Responses to Comments on Draft Initial Study/Mitigated Negative Declaration

Walnut Grove Residential Project

SCH No. 2020110322

February 2021

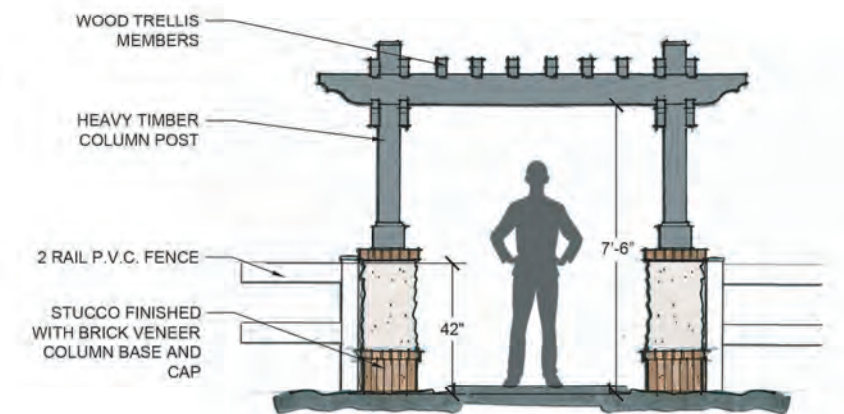
While features such as internal paseos and walkways are included in the Project to accommodate pedestrians, in light of the commenter's comments and to accommodate use of bikes, the text of the IS/MND and the associated exhibit (Exhibit 3-6, Conceptual Park Enlargement Plan) will be revised to incorporate bike racks on-site for use by future residents of the Project and their guests. The bike racks will be provided in two locations adjacent to the mailboxes around the perimeter of the park. These revisions do not require recirculation of the IS/MND under CEQA Guidelines Section 15073.5(c)(4). The following addition is hereby

While features such as internal paseos and walkways are included in the Project to accommodate pedestrians, in light of the commenter's comments and to accommodate use of bikes, the text of the IS/MND and the associated exhibit (Exhibit 3-6, Conceptual Park Enlargement Plan) will be revised to incorporate bike racks on-site for use by future residents of the Project and their guests. The bike racks will be provided in two location adjacent to the mailboxes around the perimeter of the park. These revisions do not require recirculation of the IS/MND under CEQA Guidelines Section 15073.5(c)(4). The following addition is hereby made to the text of the IS/MND under Section 3.1, Residential Land Use, on page 3-2 of the IS/MND (new text is shown in *red italics*):

The above modification will also be reflected in Exhibit 3-6, Conceptual Park Enlargement Plan. The exhibit is hereby modified to incorporate the proposed bike racks. The updated exhibit is included in Section 4.0, Revisions as Part of the Final IS/MND.

The above modification will also be reflected in Exhibit 3-6, Conceptual Park Enlargement Plan. The exhibit is hereby modified to incorporate the proposed bike racks. The updated exhibit is included in the following page.

- ① Landscape Berming.
- ② 42" Tall 2 Rail P.V.C. Fencing.
- ③ Wood Arbor Trellis Entry.
- ④ Trash Receptacle.
- ⑤ Bench Seating.
- ⑥ 5' Wide Medium Bloom Natural Concrete Path.
- ⑦ Children's Tot-Lot with Play Equipment, Swing Set and Rubber Surfacing.
- ⑧ Pre-Fabricated Covered Structure with Decorative Column Post and Picnic Table Seating.
- ⑩ Open Turf Play Area.
- ⑪ Concrete Header.
- ⑫ Gang Mailbox Location.
- ⑬ Bike Racks.
